# Technical Service Information

## FORD 4F50N 1-2 SLIDE / BANG

**COMPLAINT:** 2004 and newer Ford vehicles equipped with the 4F50N transaxle may exhibit a 1-2 slide bang before or after overhaul.

Figure 3

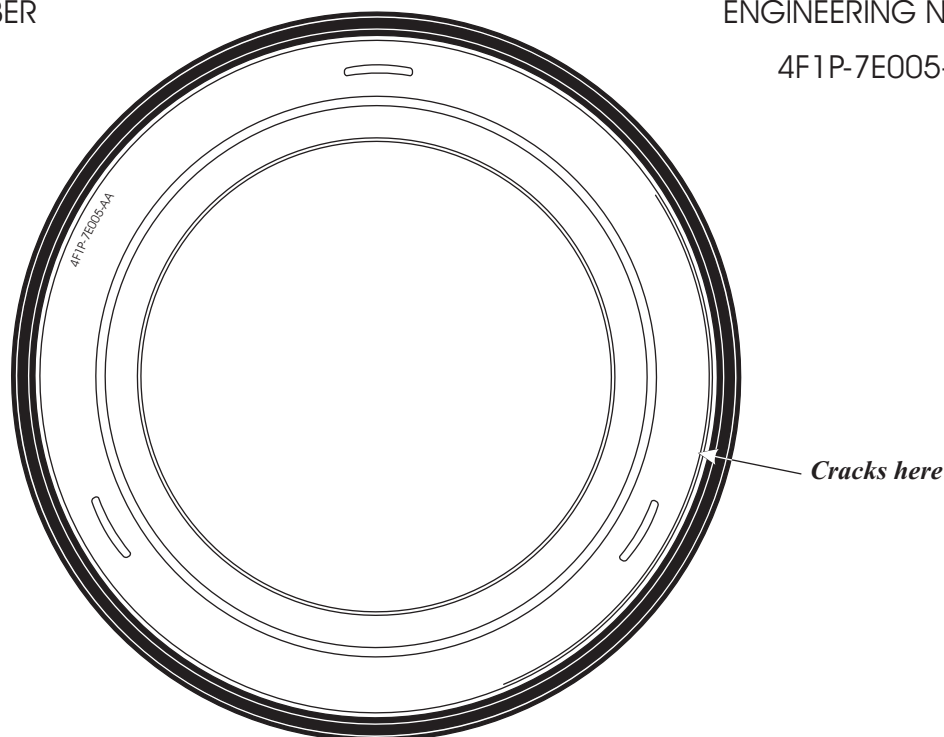
**CAUSE:** The cause may be, a cracked Intermediate Piston, as shown in Figure 3, or a weak 1-2 Capacity Modulator Valve Spring. Note: 2004 and Up 4F50N are equipped with the 1-2 Capacity Modulator Valve that controls the rate of application of the Intermediate Clutch, like the previous 1-2 Capacity Modulator Valve on the AXOD/AX4S. See Figure 4.

*An updated piston can be identified by the engineering number printed on the bottom side of the piston as seen in figure 3. This number is slightly different than the part number.*

PREVIOUS DESIGN  
ENGINEERING NUMBER  
F88P-7E005-AA

NEW DESIGN  
ENGINEERING NUMBER  
4F1P-7E005-AA

**CORRECTION:** To correct this condition, replace the Intermediate piston with an updated piston from Ford or from your parts distributor as some distributors sell the O.E. pistons. Install a heavier spring into the 1-2 Capacity Modulator valve line-up. Note: the 2-3 Capacity Modulator Valve spring is the same as the 1-2 , if a firmer 2-3 upshift is desired , a firmer spring can be used there also. See Service information for available aftermarket replacement springs. *Note: the 1-2 and 2-3 Capacity Modulator Valve springs are identical so 2 aftermarket springs can be used, to cover 2nd and 3rd gear shift feel, per transmission overhaul.*

Figure 4

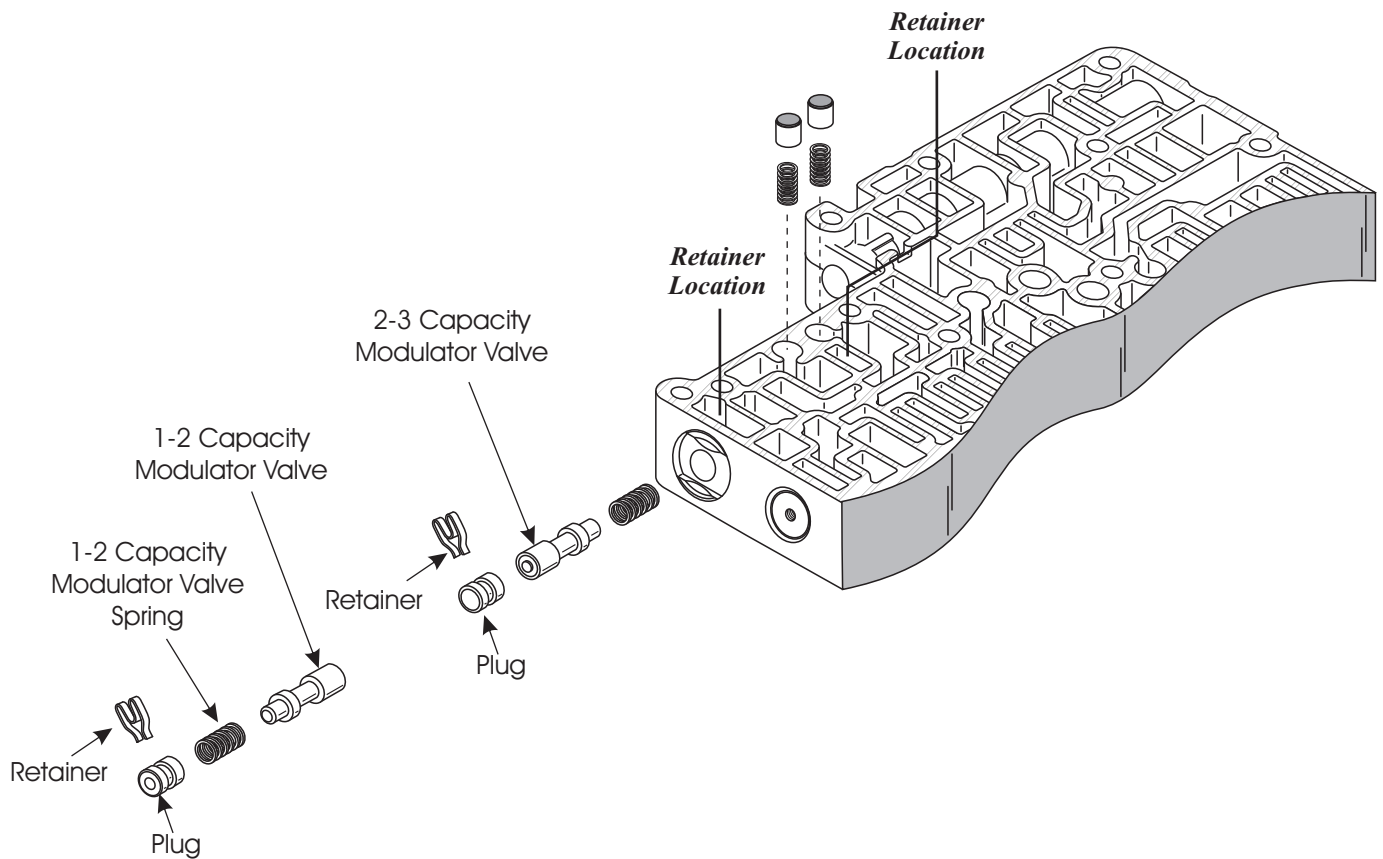
*Note: The 1-2 and 2-3 Capacity Modulator valve springs are the same*
